ALLEGHENY COUNTY SANITARY AUTHORITY

CONTRACT NO. 1729 G, E, H, P

EAST HEADWORKS

ADDENDUM NO. 7

Contract: 1729
CAD File Name: 530-A-38.DGN
Date: OCTOBER 2020
Sheet: 103 of 645

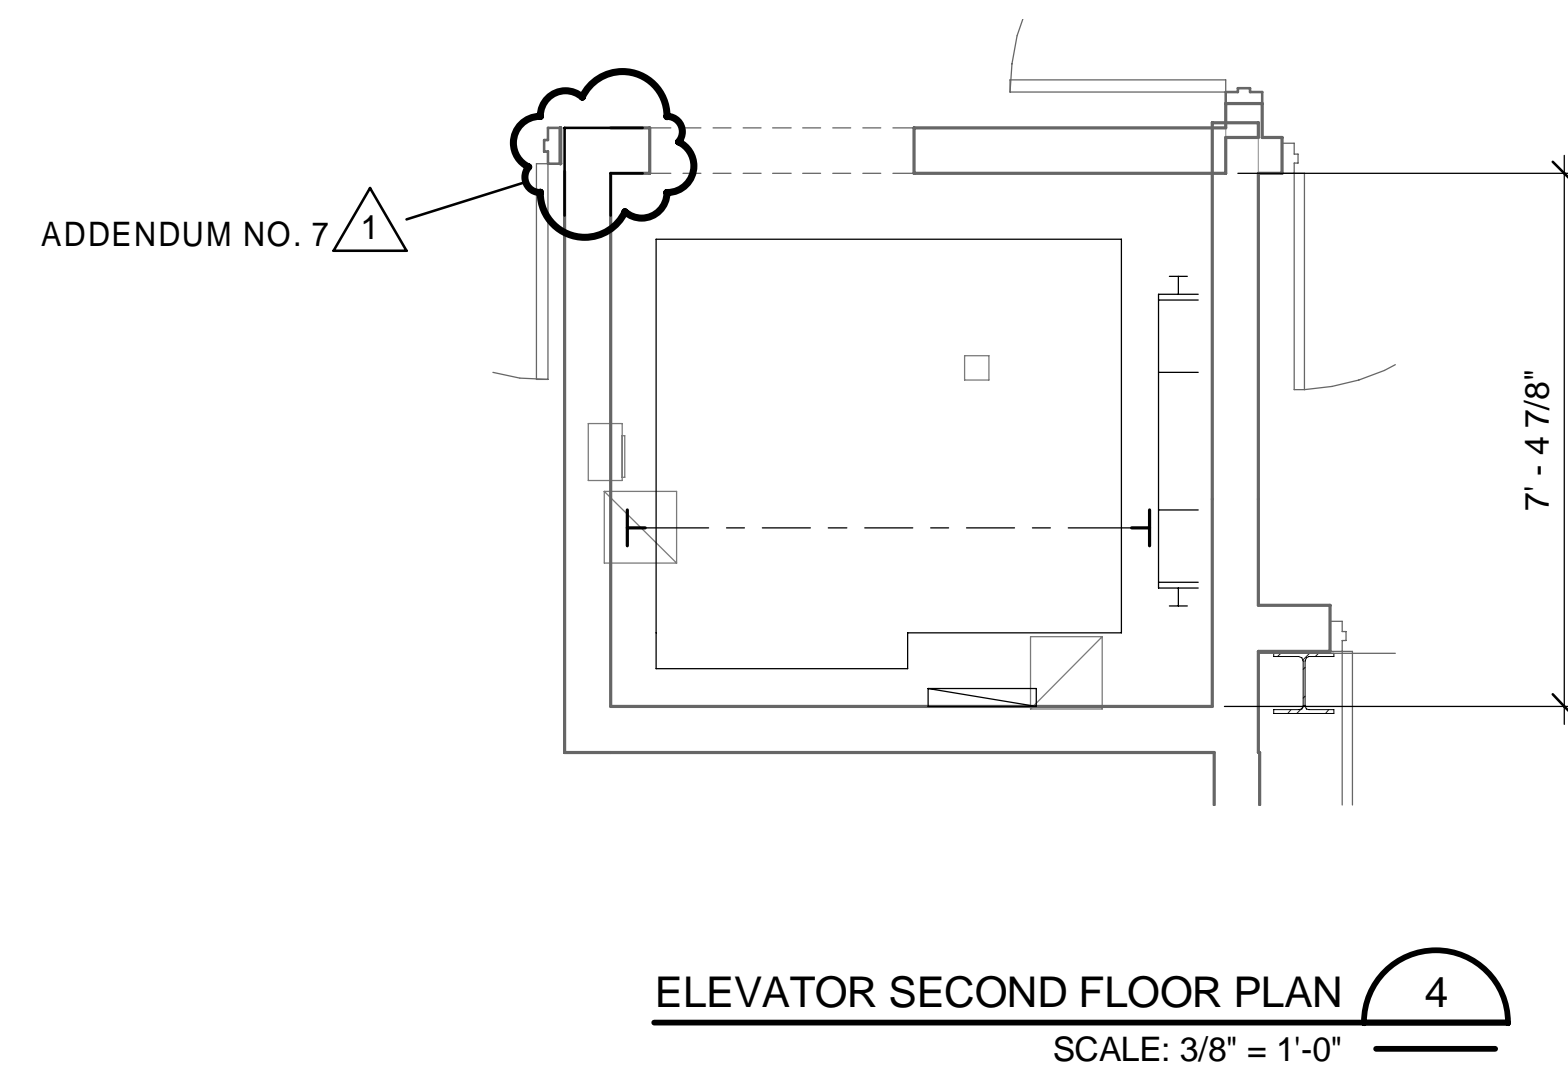
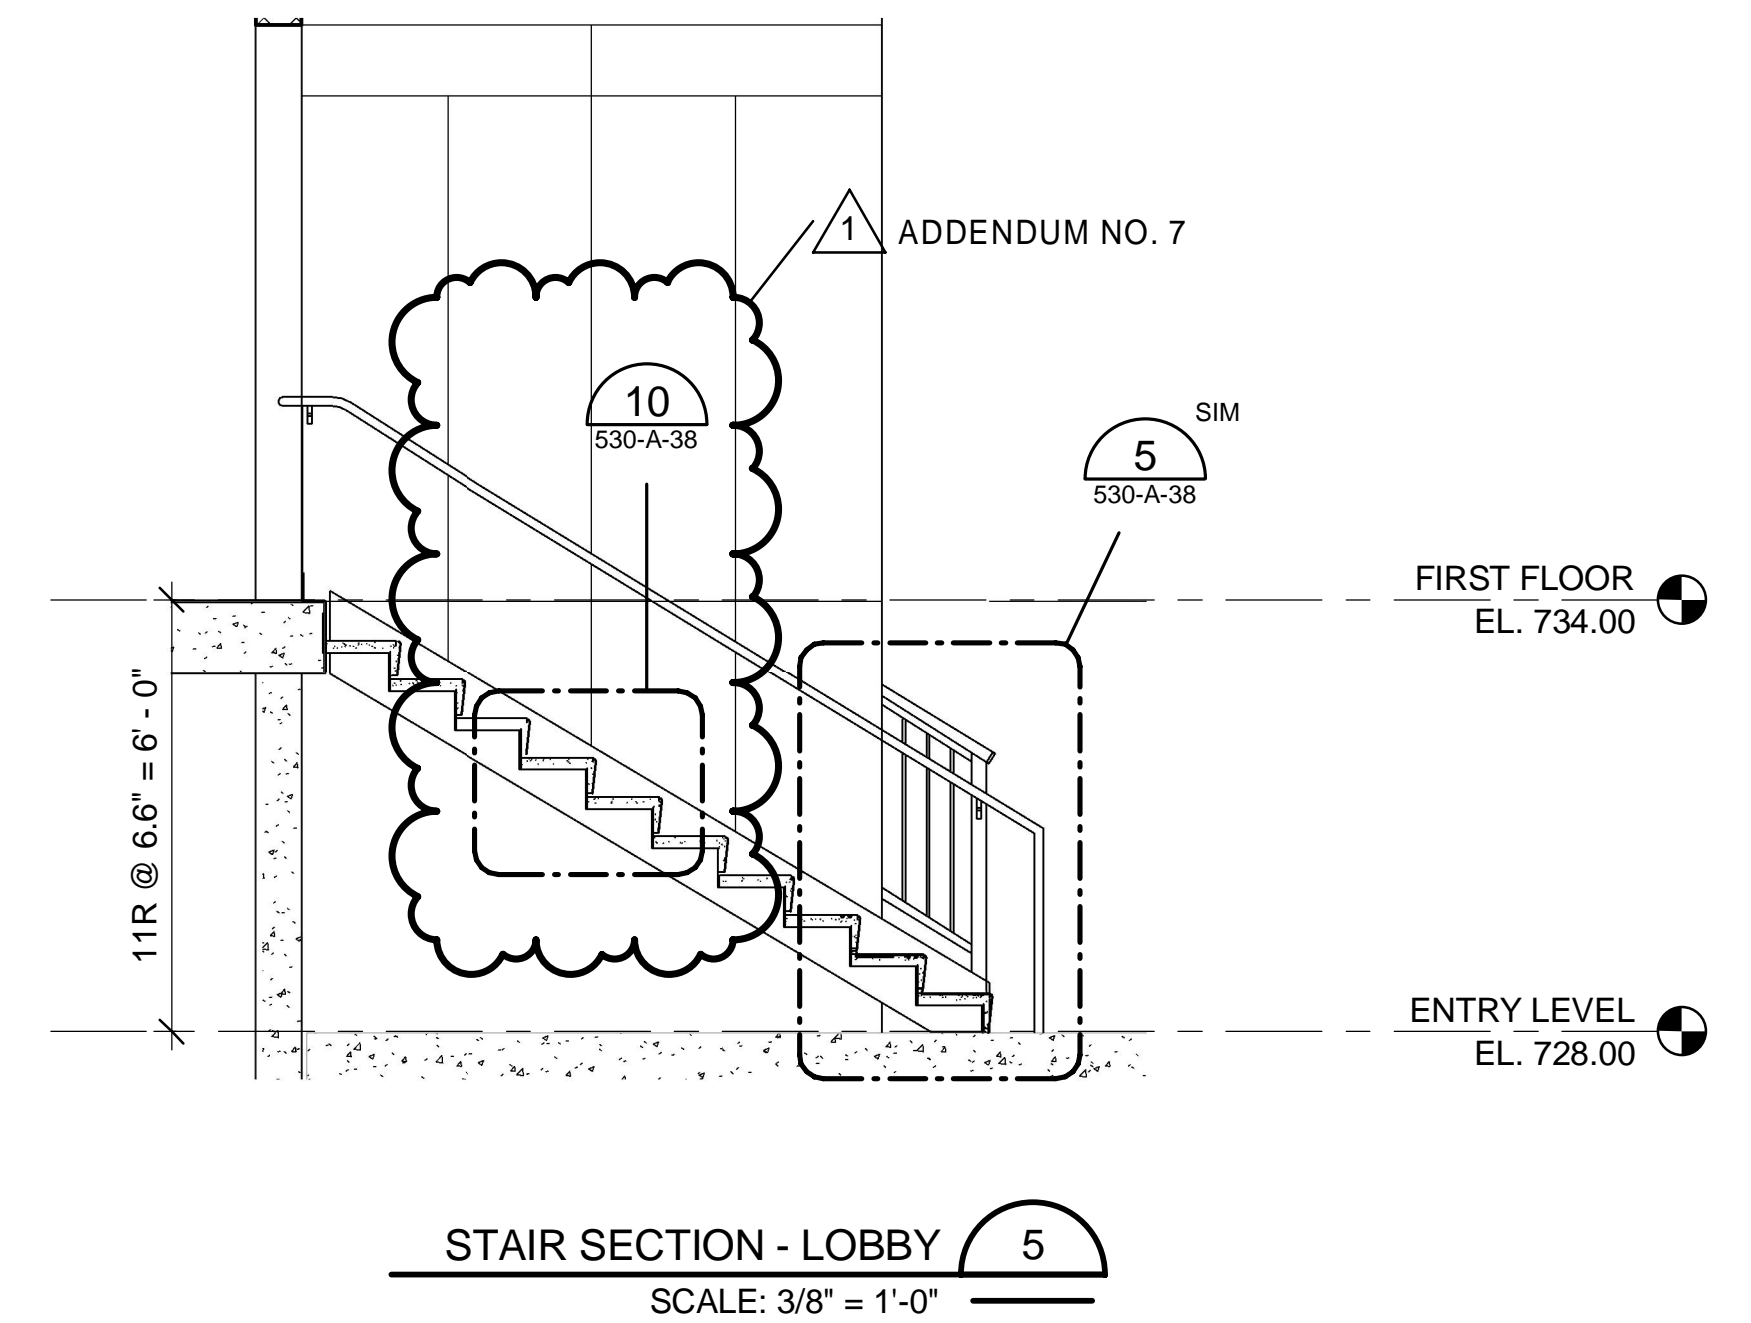
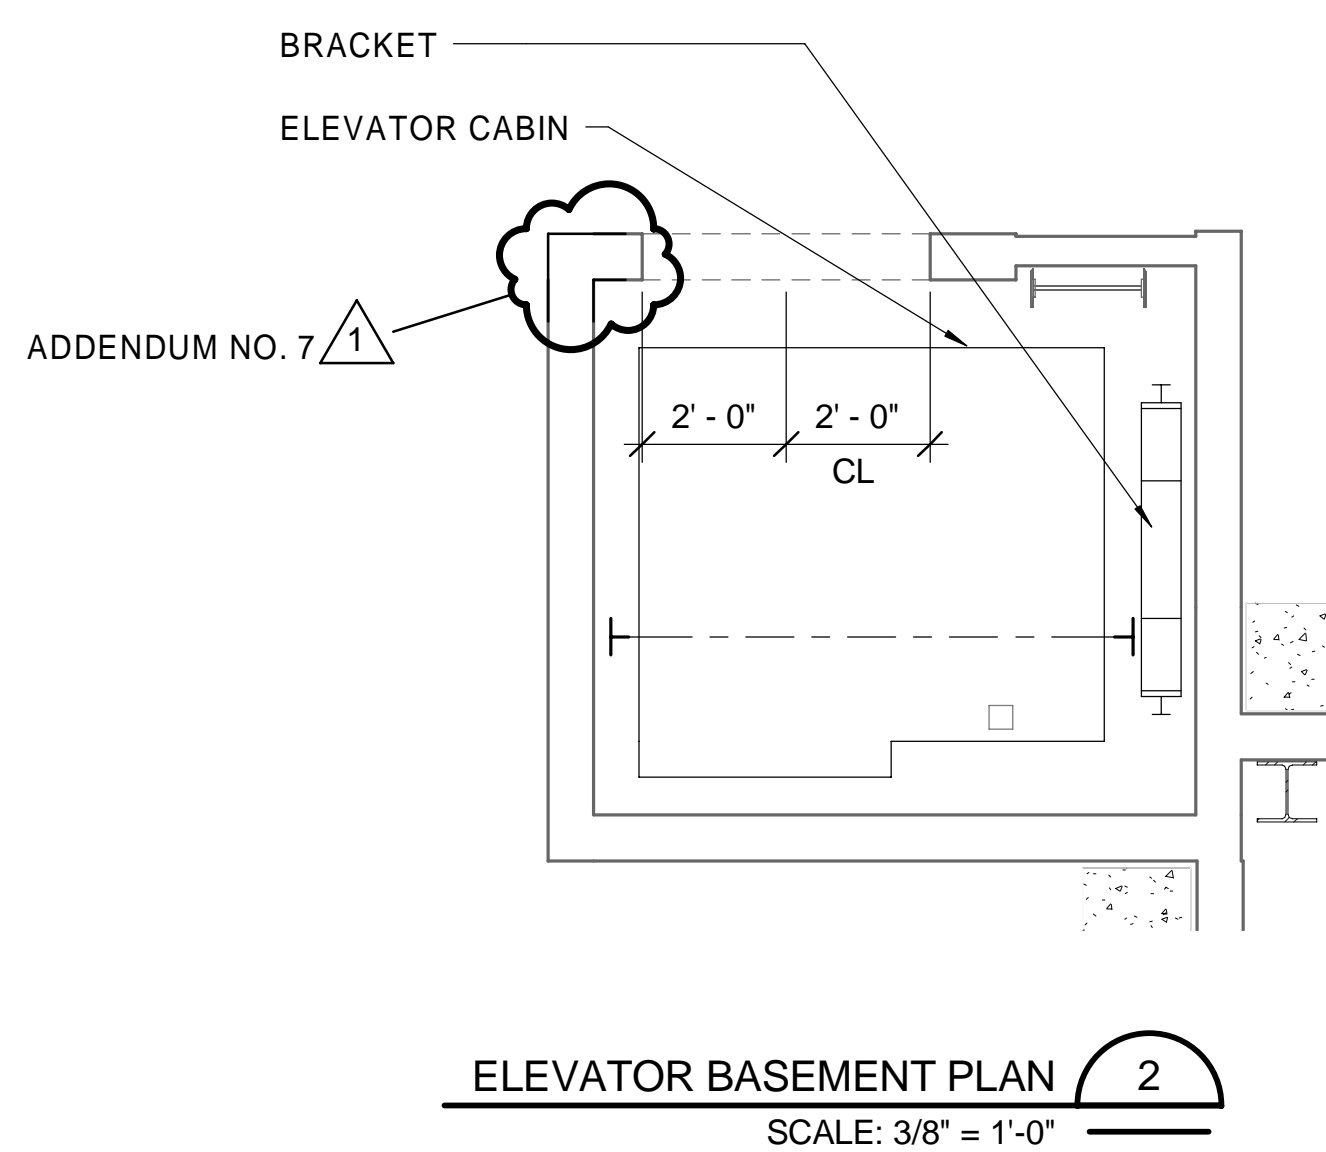
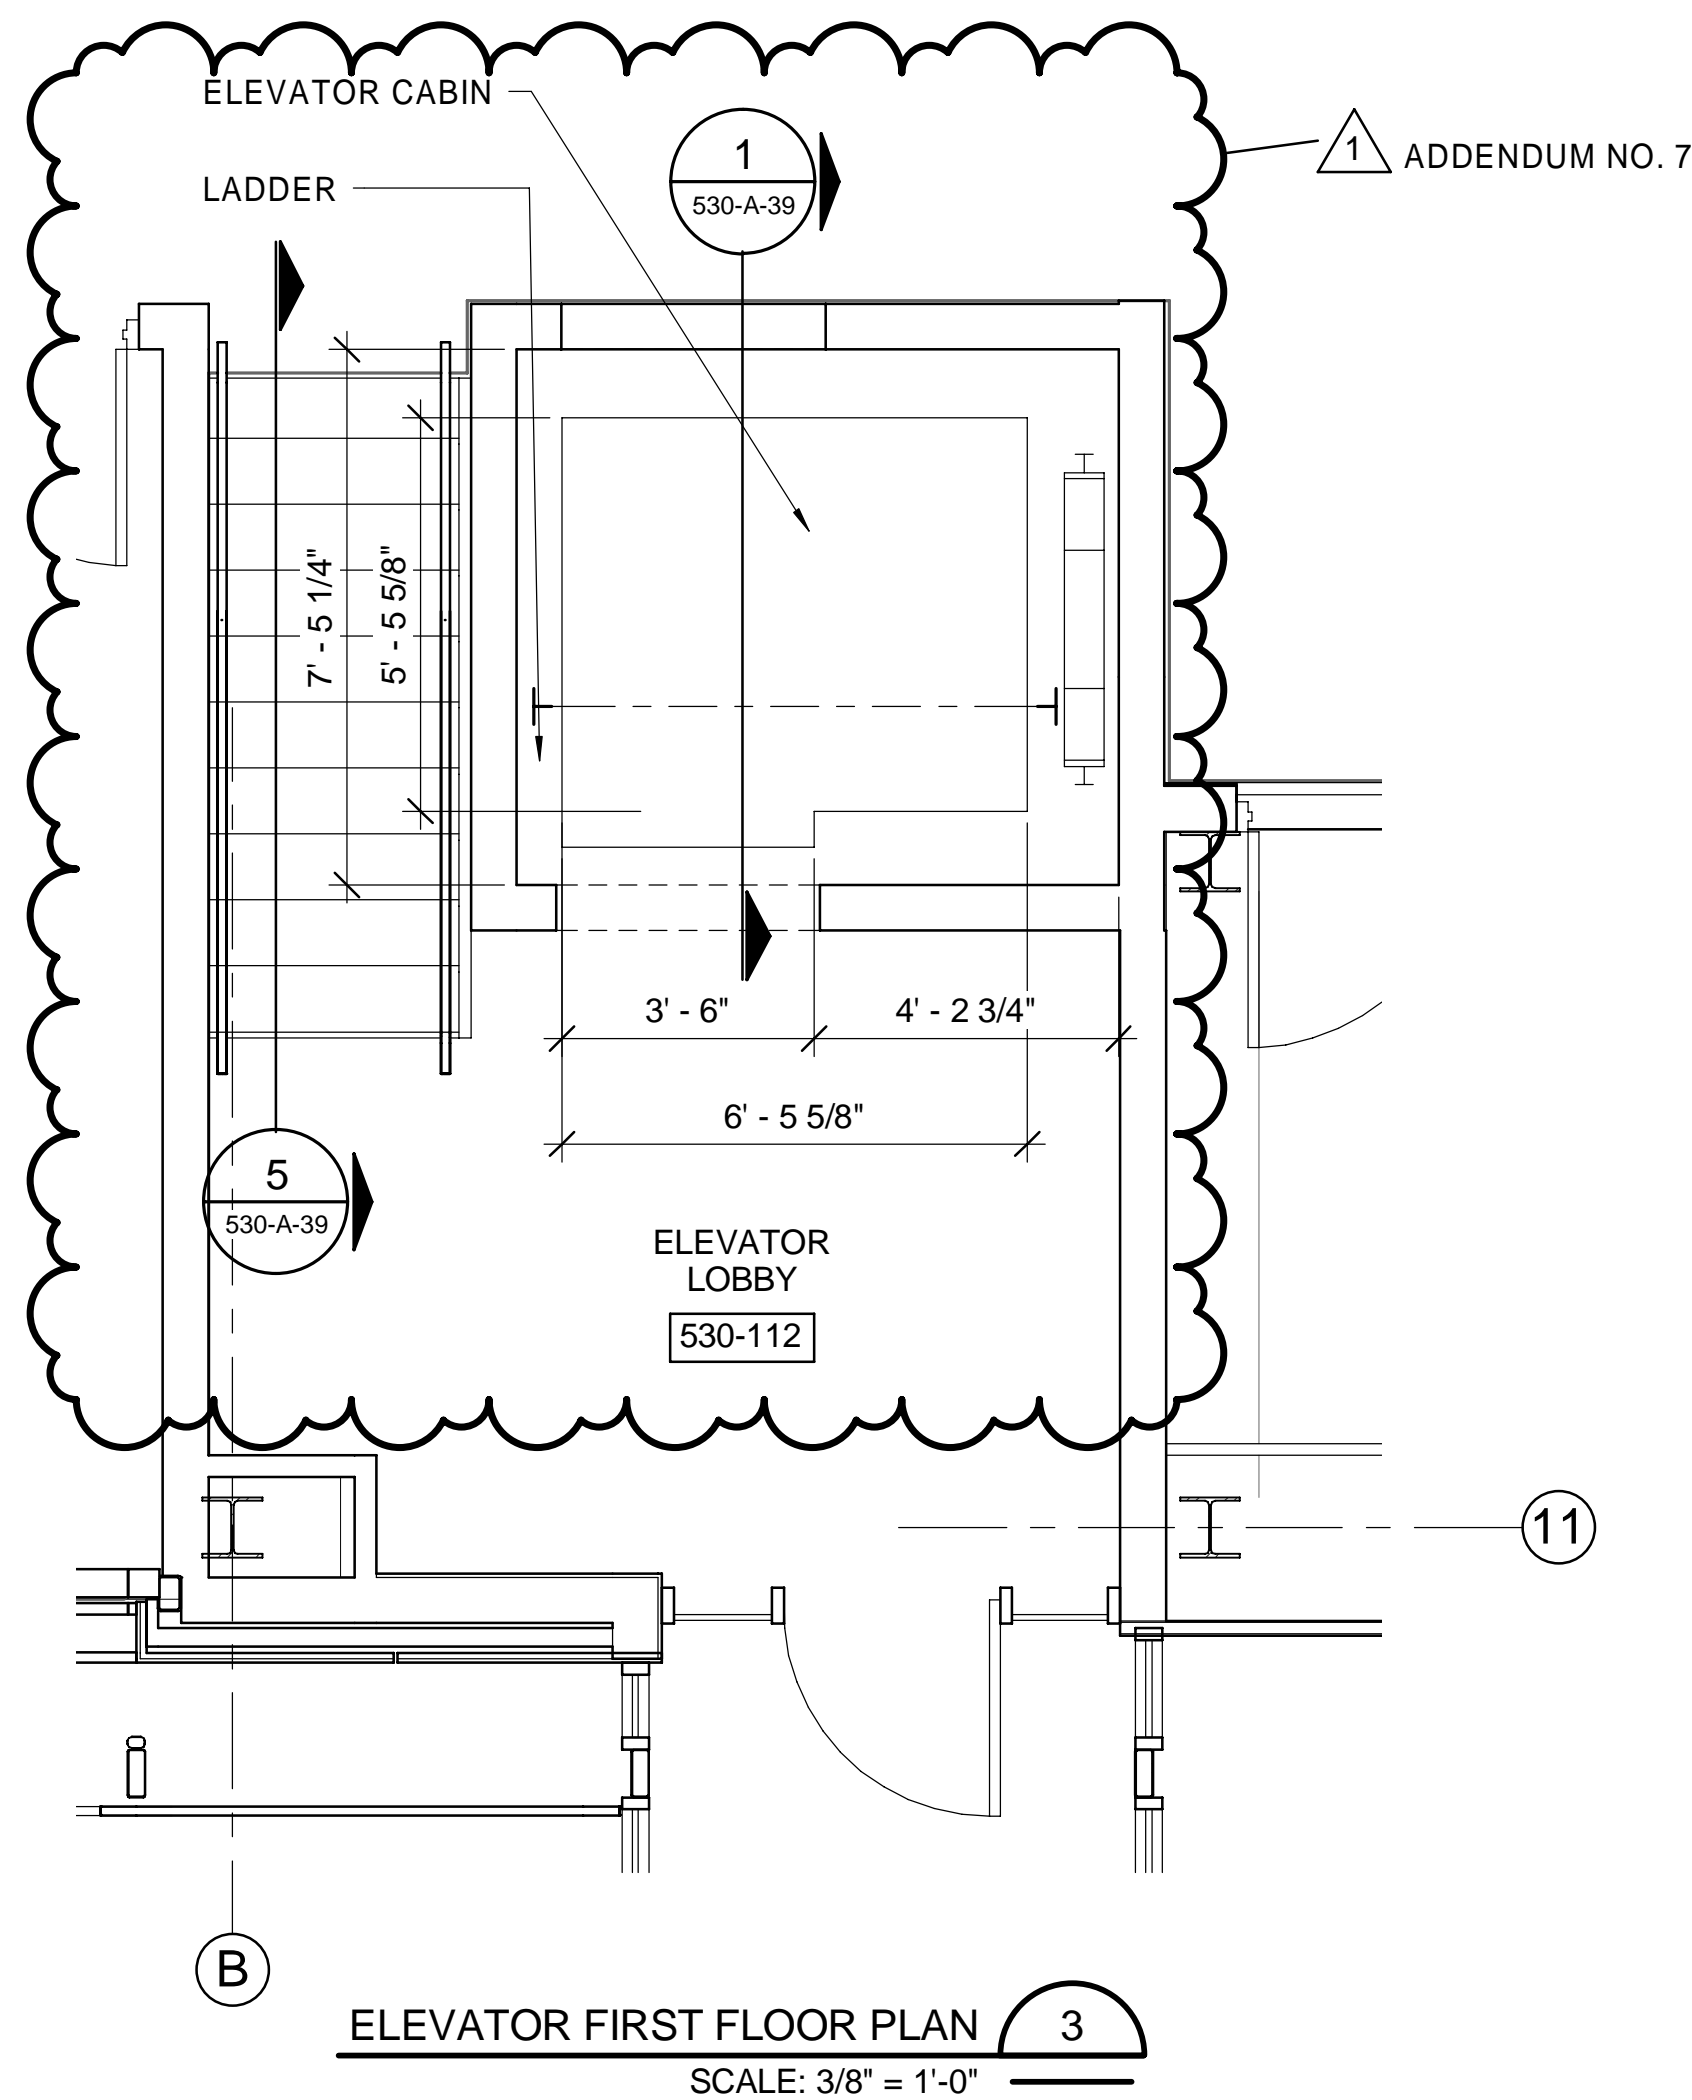
133. **QUESTION:** Reference drawing 530-A-37 (102 of 645), in section 1 for Stair 2 there are 2ea detail call outs numbered 1 and 3 from drawing 530-A-38 located near the top of the section view. On drawing 530-A-38 detail 1 and detail 3 are for railing details where there is not railing shown on 530-A-37. Also reference drawing 530-ELP-10 which shows the stairs extending to uppermost level of stair 2 as opposed to 530-A-37. It appears that drawing 530-A-37 may have been issued incorrectly and that the intent was to extend the stairs all the way to the top of the stairwell as indicated in 530-ELP-10. Please advise.

RESPONSE: The uppermost level of the stair was omitted from the drawing. The intent is for Stair 2 to terminate at the Penthouse Floor Level (Elevation 766). Refer to revised drawings 530-A-23, 530-A-28, and 530-A-36 through 39, issued with Addendum No. 7.
